6-12 Peters Avenue, Wallsend Traffic Impact Assessment

Traffic Impact Assessment

**RE: 6-12 PETERS AVENUE, WALLSEND – LAHC
TRAFFIC RESPONSE TO COUNCIL RFI**

Figure 2: Probability of Conflict Analysis

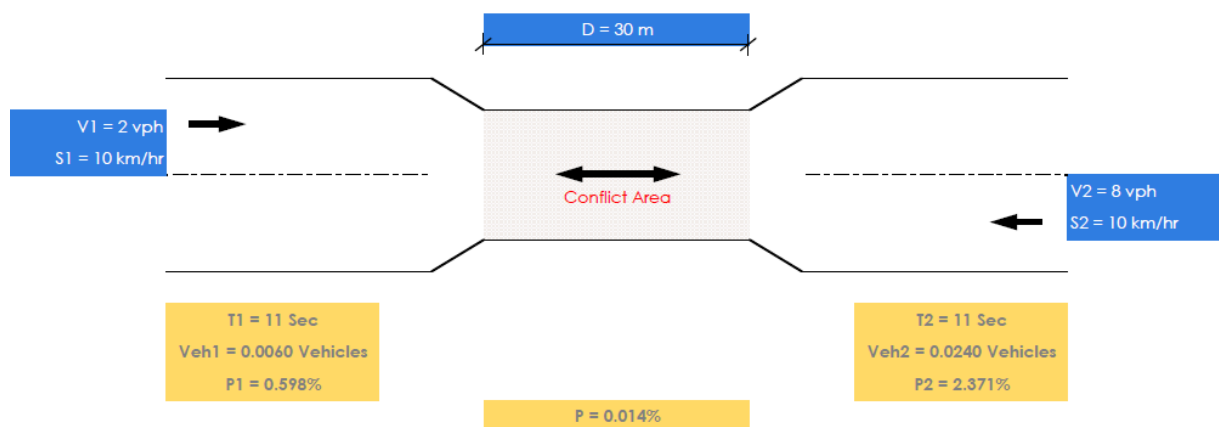
The width of the access driveway be adjusted to 5.5m in the road reserve and extend six metres into the property.

To assess the adequacy of the proposed access arrangements and ensure that there would be minimal delay and impact to the traffic operation of Peters Avenue, a probability of conflict analysis has been undertaken.

Based on a traffic generation of up to 10 vehicles per hour and an 80%/20% split of inbound and outbound traffic, it is estimated that there would be an opposing flow of 8 vehicles per hour against 2 vehicles per hour over a driveway distance of 30m (rounded up from 27m for the purposes of this assessment).

On this basis, the probability of two opposing vehicles arriving at the same is 0.014%, which is a low probability of conflict.

Therefore, there is a low probability of vehicles meeting each other on the driveway and one needing to reverse out.

Figure 2: Probability of Conflict Analysis

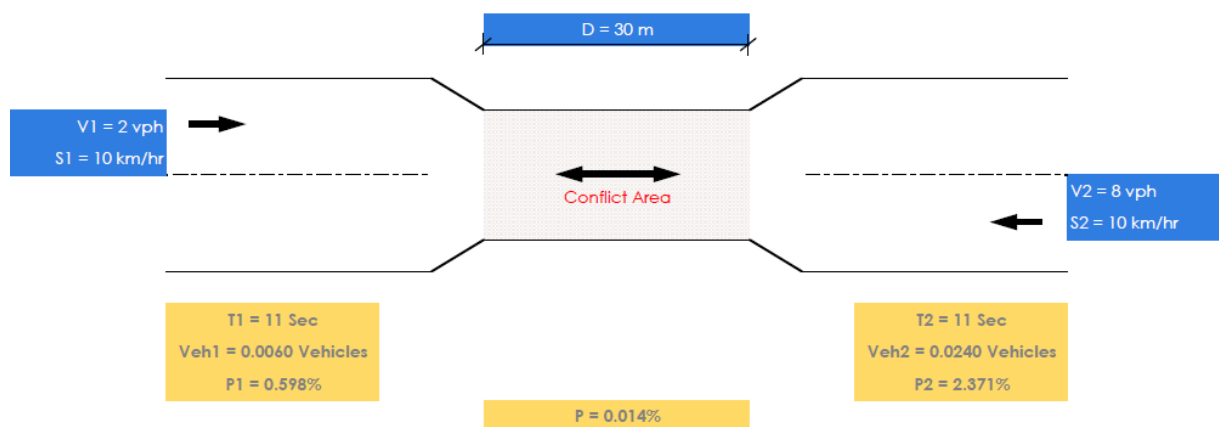
The width of the access driveway be adjusted to 5.5m in the road reserve and extend six metres into the property.

To assess the adequacy of the proposed access arrangements and ensure that there would be minimal delay and impact to the traffic operation of Peters Avenue, a probability of conflict analysis has been undertaken.

Based on a traffic generation of up to 10 vehicles per hour and an 80%/20% split of inbound and outbound traffic, it is estimated that there would be an opposing flow of 8 vehicles per hour against 2 vehicles per hour over a driveway distance of 30m (rounded up from 27m for the purposes of this assessment).

On this basis, the probability of two opposing vehicles arriving at the same is 0.014%, which is a low probability of conflict.

Therefore, there is a low probability of vehicles meeting each other on the driveway and one needing to reverse out.
